5.2 NO. 188 (LOT: 1; D/P: 33790) VINCENT STREET, NORTH PERTH - PROPOSED ALTERATIONS AND ADDITIONS TO PLACE OF WORSHIP (AMENDMENT TO APPROVED)

The purpose of this report is to consider an application for development approval for Alterations and Additions to Place of Worship (Amendment to Approved) at No. 188 Vincent Street, North Perth (the subject site).

Drawing No **A228**

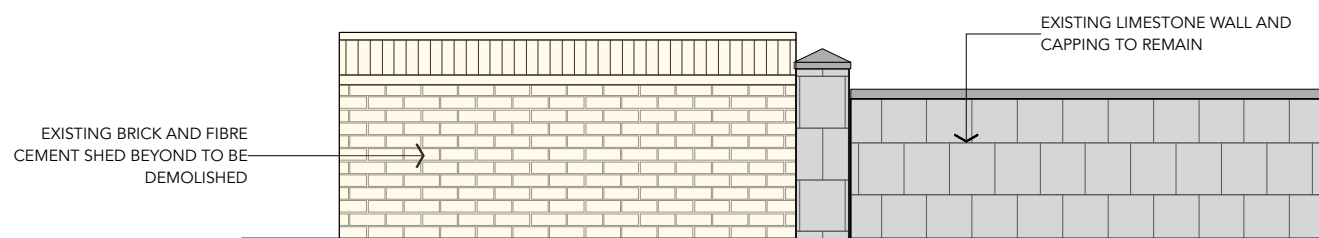
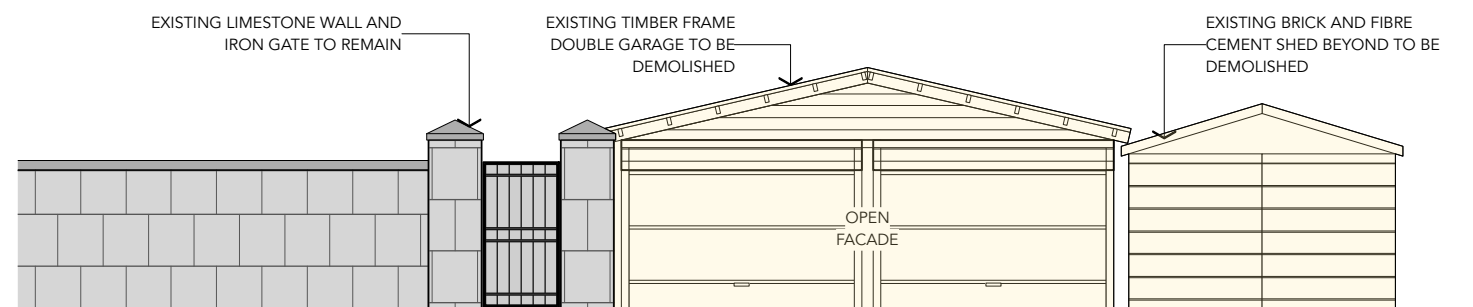
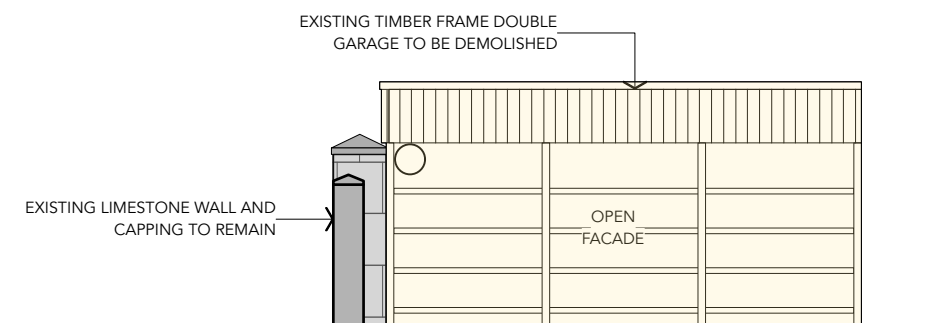
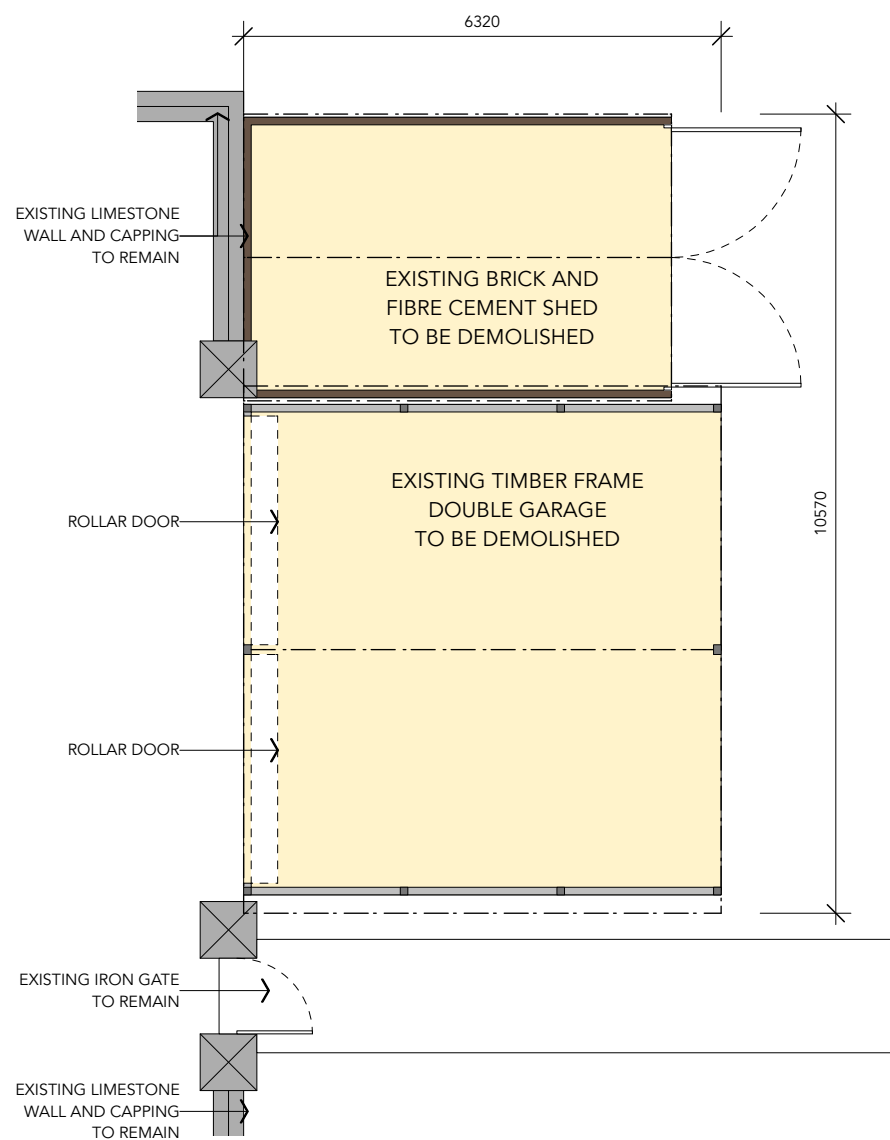
- The garage and shed (the outbuildings) are not recorded as buildings or elements of significance in the Conservation Plan or in the Heritage Council's Register Entry or Assessment Documentation;

- The proposed demolition would not impact upon the heritage significance of the place because the outbuildings are not original to the place and not included in the Statement of Significance for the site;

- Demolition would not Impact Heritage Significance: The demolition of the existing outbuildings would have no impact on the cultural heritage significance of the place, including no impact to the structural integrity of the remainder of the heritage building. This is because the outbuildings are freestanding and are separated from the Church by 4.3 metres. These two outbuildings are in poor condition. A review of aerial imagery indicates that the outbuildings to be demolished were constructed between 1965 and 1974 and are not part of the original fabric of the Church and Monastery. Neither of these outbuildings form part of the heritage significance of the place as detailed within the Statement of Significance or Conservation Plan. The Conservation Plan does not include recommendations for the retention or demolition of these buildings;

Drawing No **A229**

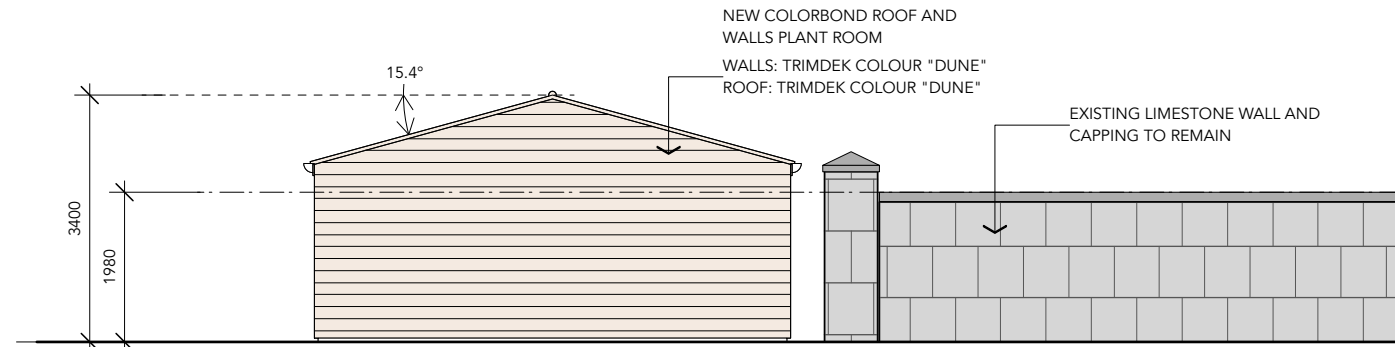
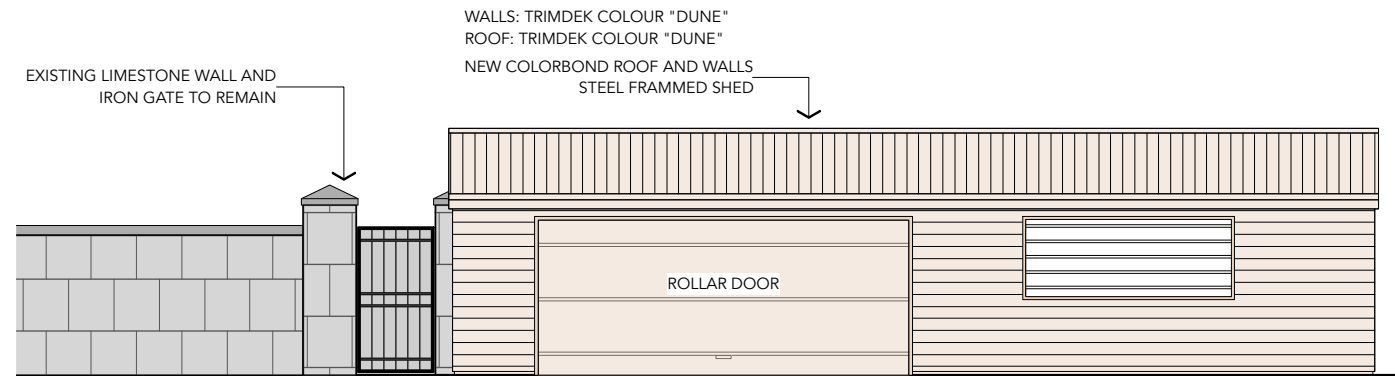
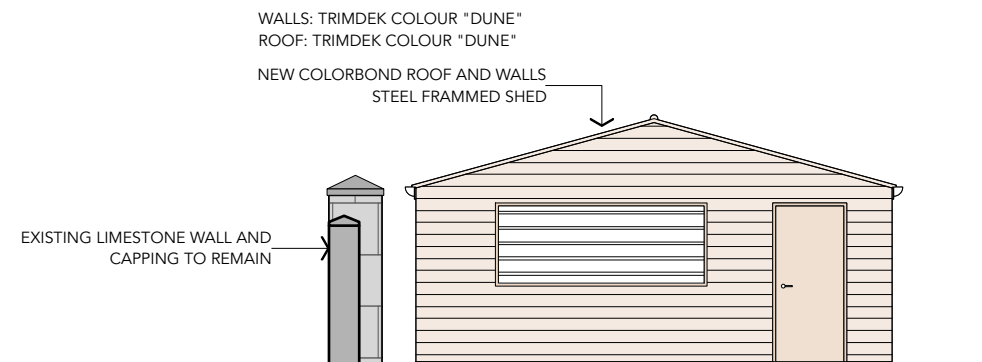
- The proposed building is not sympathetic to the existing Church and Monastery building due to its materiality (Colorbond) and design;
- The proposed building does not complement the existing building by referencing or interpreting the scale, rhythm and materiality of the Church;
- The proposed location obscures the surrounding viewing space of the church and historical gardens, Vista and view lines would be negatively impacted due to the location of the proposal;
- Request for rendered perspectives to be provided and elevations to include the adjacent Church, garden, car park; and
- Provide suggestions for alternative designs for the outbuilding including built form, location and materiality.

The DRP Member supported the proposal, and provided the following comments on the proposal:

- The proposed structure is not attached to significant building fabric;
- The replacement outbuilding is noted as 'Colorbond' clad and roofed. The proposed colour 'Dune' is acceptable;

- To interpret the three storey Church building's scale, rhythm, and materiality in the construction of a building to be used for utilitarian purposes for a limited time is not required. It would complicate a simple structure to be used for the purpose of housing infrastructure to service the significant buildings. The material selection is appropriate as a utility structure. Referencing the existing building style or materials is not appropriate in terms of conservation principles and practice;

- The proposed outbuilding is in the same location as the existing outbuildings that do not have heritage significance and is well away from important views from Vincent Street. The landmark value of the Church and Monastery is maintained.

- The location and design of the proposed outbuilding would be subservient to the Church to the south east. The proposed outbuilding has been designed to be similar to the existing outbuildings on-site in terms of size and location. The larger of the existing outbuildings is clad in sheet metal and was approved to be reclad as part of the previous approval. The utilitarian design and use of sheet metal is consistent with other outbuildings on the site and was noted by the DRP member as an appropriate material for a utility structure;

- Sympathetic to Existing Heritage Values: The proposed outbuilding would be in the same location as existing outbuildings. Outbuildings are an established part of the built form of the site. The proposed materials and finishes are consistent with existing outbuildings within the wider Monastery and Church complex which have typically been utilitarian in nature. These include the corrugated metal outbuildings to the north of the Formal Garden. The proposed outbuilding would be finished in a neutral 'Dune' colour, 'trimdek' sheet profile and steel-framed construction and would be modest in scale in the context of the subject site and adjoining Church. It would measure 12.3 metres long by 6.3 metres wide, with a wall and ridge height of 2.2 metres and 3.4 metres respectively. This would ensure that it would be subservient to the adjacent Church, which has a wall height of approximately 9.7 metres;

- Site Presentation to Alfonso Street:** The existing southernmost outbuilding presents two garage doors in a sheet metal wall to the Alfonso Street elevation. The proposed outbuilding would provide a sheet metal wall, with a roller door to the Alfonso Street elevation. Across the entire Alfonso Street elevation of the subject site, the Church and Monastery buildings would provide visual interest to Alfonso Street. This includes the Narthex that was approved by Council in December 2022. In addition to the existing limestone Church, the Narthex would sit 6.4 metres forward of the proposed outbuilding and includes large format glazing and copper roofing to complement the existing Church; and

Images Included with Submissions

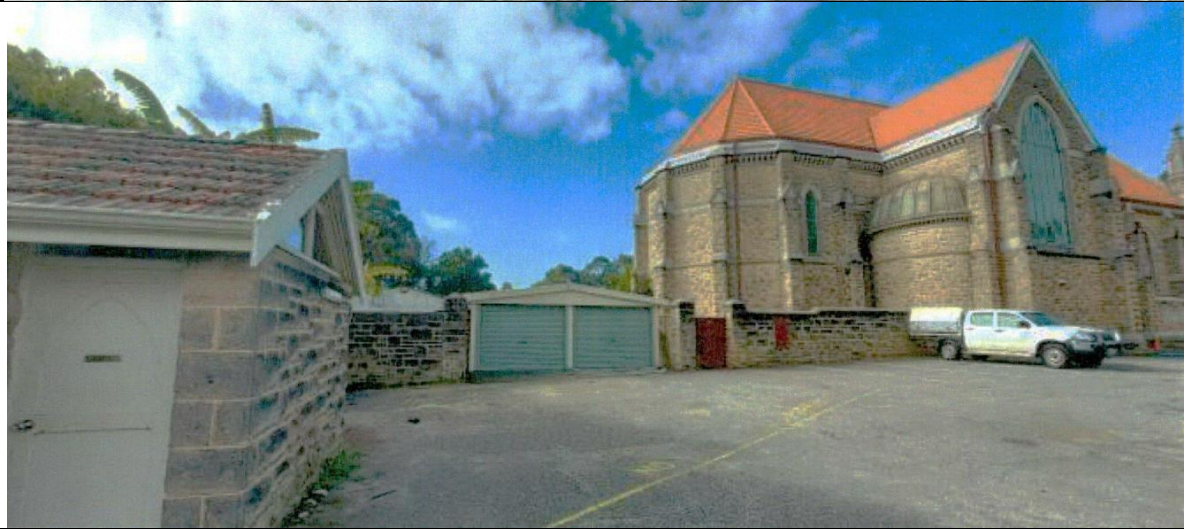
Enhance vista from Alfonso Street by removing the Colorbond gabled shed and exposed roller doors.

Relocating the plant room behind the existing garden wall will allow breathing space and appropriate distancing to the Church ambulatory.

Relocated and realigned plant room to provide great separation to the Ambulatory and enhance vistas.

Comments Received In Objection:	Administration Comment
<p><u>Comments on Plans</u></p> <ul style="list-style-type: none"> • Suggestions for modifications to the proposal as follows: <ul style="list-style-type: none"> ○ Locate a new Plant Room on an East/West axis behind the existing limestone garden wall, in line with the adjacent existing amenities building. This would ensure the new building is visually obscured when viewed from the existing western carpark and Alfonso Street. It would also be located further from the north end of the church (Refer Images below). This would increase the space to the north of the church, enhancing vistas and allowing greater articulation to the ambulatory; ○ The large existing opening between the existing limestone garden walls is currently used to access an inappropriately domestic scaled Rolla door. The proposed design changes little, except that the gable roof now faces the Church. The opening in the limestone fence could be replaced with wrought iron gates to match the existing smaller gate adjacent. This would enable a more harmonious west elevation. The gate would allow maintenance to the Plant Room and Gardens, but more importantly, would provide for an appropriate vista of the historical gardens north of the Ambulatory. This would improve vistas from the carpark and Alfonso Street. Refer Sketch and Images below; ○ Use a flat roof behind a parapet wall or exposed steel beam to allow a linear "box" in lieu of a proposed domestic gabled garden shed. A tiled roof to match the amenities building would introduce an unsatisfactory bulkier massing too close to the Ambulatory; ○ Suggest locating single entry door, window and downpipes between the Plant room and existing garden wall to obscure these openings and services from the Street; ○ Proposed Rolla door entry if needed should be faced with same material to match adjacent wall; ○ Exposed ventilation louvres and light window should face north. A window, if needed, should be vertical in proportion. The existing landscape adjacent to the adjoining property car park would help obscure the north elevation; ○ Investigate the use of smooth limestone wall facing, compressed fibre cement sheeting or sandstone coloured blockwork to facilitate a modern and harmonious contrast to the existing Church. 	<ul style="list-style-type: none"> • These suggestions were provided to the applicant for their consideration. The applicant did not elect to modify their plans. • The City is required to consider and determine the application as proposed by the applicant, rather than possible alternatives as proposed in the community submissions and this is not a relevant planning consideration. • The proposed outbuilding is considered appropriate for the reasons outlined in the report, which are summarised as follows: <ul style="list-style-type: none"> ○ The proposal would assist with the ongoing use of the subject site as a place of worship by adapting it to reflect modern requirements, consistent with the Burra Charter and the site's Statement of Significance; ○ The proposal would not interrupt the significant vistas of the property, which are identified in the Conservation Plan as being from Vincent Street; ○ Due to the existing fences, ablutions block and landscaping, the proposed outbuilding would not impact direct views of the Church from Alfonso Street; and ○ The proposed outbuilding would be consistent with other outbuildings on the site, that are located within the park setting. The dune colour and proposed scale would ensure that the outbuilding was subservient to the Church and Monastery.
